# HISTORIC AND DESIGN REVIEW COMMISSION

**HDRC CASE NO:** 2020-068  
**ADDRESS:** 311 REFUGIO ST  
**LEGAL DESCRIPTION:** NCB 714 BLK 11 LOT 11  
**ZONING:** RM-4  
**CITY COUNCIL DIST.:** 1  
**DISTRICT:** Lavaca Historic District  
**APPLICANT:** Brian Voges/Voges Design  
**OWNER:** Houston Carpenter  
**TYPE OF WORK:** New construction of two, 2-story residential structures with a 1-story connected rear garage structure  
**APPLICATION RECEIVED:** January 31, 2020  
**60-DAY REVIEW:** March 31, 2020  
**CASE MANAGER:** Rachel Rettaliata

## REQUEST:

**1** SITE PLAN  
SCALE: 1/8" = 1'

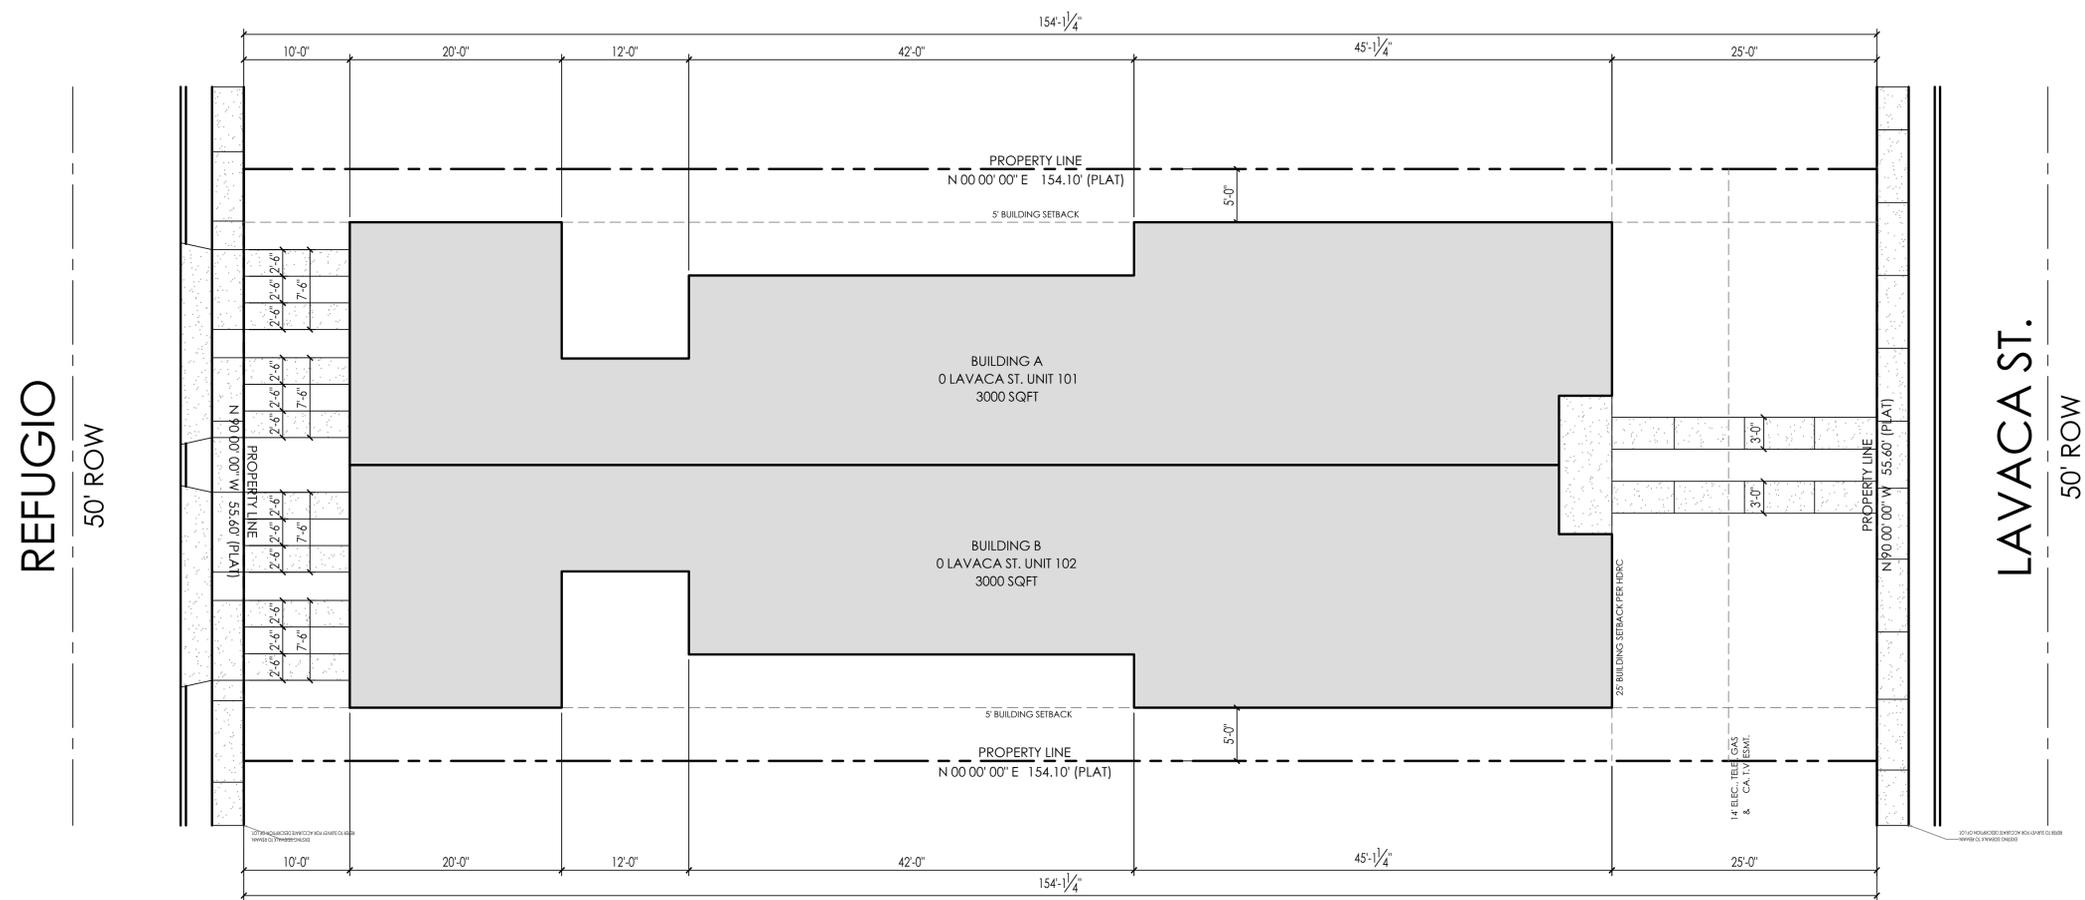
- d. **SETBACK & ORIENTATION (REFUGIO)** – According to the Guidelines for New Construction, the front facades of new buildings should align with the front facades of adjacent buildings where a consistent setback has been established along the street frontage. Additionally, the orientation of new construction should be consistent with the historic examples found on the block. The applicant has proposed to construct two 2-story, single-family residences at 311 Refugio. The residences will be attached and the entrances will face Lavaca. The rear of the structure features a connected, 1-story, 4-car garage facing Refugio. The applicant has noted that the proposed setback from Refugio will be 10 feet. Adjacent structures feature setbacks that range from approximately 10 to 20 feet. The Historic Design Guidelines for New Construction stipulate that primary building entrances should be oriented towards the primary street and that front facades should be aligned with the front facades of adjacent buildings. Historically, homes have had frontage on both Refugio and Lavaca Streets. Staff finds that it is inappropriate for a new development to only address one frontage and to construct front-loading garages on the other. Staff finds that the overall setback and orientation should be more consistent with the proposal that received conceptual approval from the HDRC on January 17, 2019, as noted in finding b.

- e. **SETBACK & ORIENTATION (LAVACA)** – According to the Guidelines for New Construction, the front facades of new buildings should align with the front facades of adjacent buildings where a consistent setback has been established along the street frontage. Additionally, the orientation of new construction should be consistent with the historic examples found on the block. The applicant has noted that the proposed setback from Lavaca will be 25 feet, which is generally consistent with adjacent structures. Staff finds that the applicant should provide a setback diagram noting the proposed setback is appropriate and consistent with the Guidelines.

- f. **ENTRANCES** – According to Guideline 1.B.i for New Construction, primary building entrances should be oriented towards the primary street. Staff finds the proposal for the primary entrance on Lavaca Street appropriate; however, staff does not find the proposed entrance configuration for Refugio Street appropriate.

- j. LOT COVERAGE – Guideline 2.D.i for New Construction stipulates that building to lot ratio for new construction should be consistent with adjacent historic buildings. Limit the building footprint for new construction to no more than 50 percent of the total lot area, unless adjacent historic buildings establish a precedent with a greater building to lot ratio. The proposed new construction will cover more than 50 percent of the total lot area. The adjacent historic buildings do not establish a precedent for this amount of coverage. Staff finds the proposal inconsistent with the Guidelines.

- n. DRIVEWAYS – Guideline 5.B.i for Site Elements notes that new driveways should be similar to those found historically within the district in regards to their materials, width, and design. Additionally, the Guidelines note that driveways should not exceed ten (10) feet in width. The applicant has proposed to install two ribbon driveways fronting Refugio. While ribbon driveways are appropriate for the district, a 4-car garage fronting the entire width of a primary residential street is not appropriate. Staff finds the driveway configurations from the previous conceptual approval more appropriate.

- q. LANDSCAPING PLAN – At this time, the applicant has not provided a landscaping plan. However, per the conceptual renderings, the applicant has proposed a low front wall, which does not have a precedent in the vicinity and should be eliminated. The applicant should install landscape elements that are consistent with those found historically on the blocks.

- i. That the applicant reconfigures the overall site design to propose residential structures that address both Refugio and Lavaca as noted in findings d, e, and f. The current site configuration is not appropriate.

- ii. That the applicant proposes a driveway configuration that locates driveways on the sides of proposed residential structures in lieu of a 4-car garage fronting a primary residential street as noted in finding n.

- iv. That the applicant submit a setback diagram to staff for review and approval, noting that proposed setbacks are consistent with the Guidelines.
- v. That the applicant submit final window specifications for the proposed replacement windows to staff for review and approval. Wood or aluminum-clad wood windows are recommended and should feature an inset of two (2) inches within facades and should feature profiles that are found historically within the immediate vicinity. Meeting rails must be no taller than 1.25” and stiles no wider than 2.25”. White manufacturer’s color is not allowed, and color selection must be presented to staff. There should be a minimum of two inches in depth between the front face of the window trim and the front face of the top window sash. This must be accomplished by recessing the window sufficiently within the opening or with the installation of additional window trim to add thickness. Window trim must feature traditional dimensions and architecturally appropriate sill detail. Window track components must be painted to match the window trim or concealed by a wood window screen set within the opening.
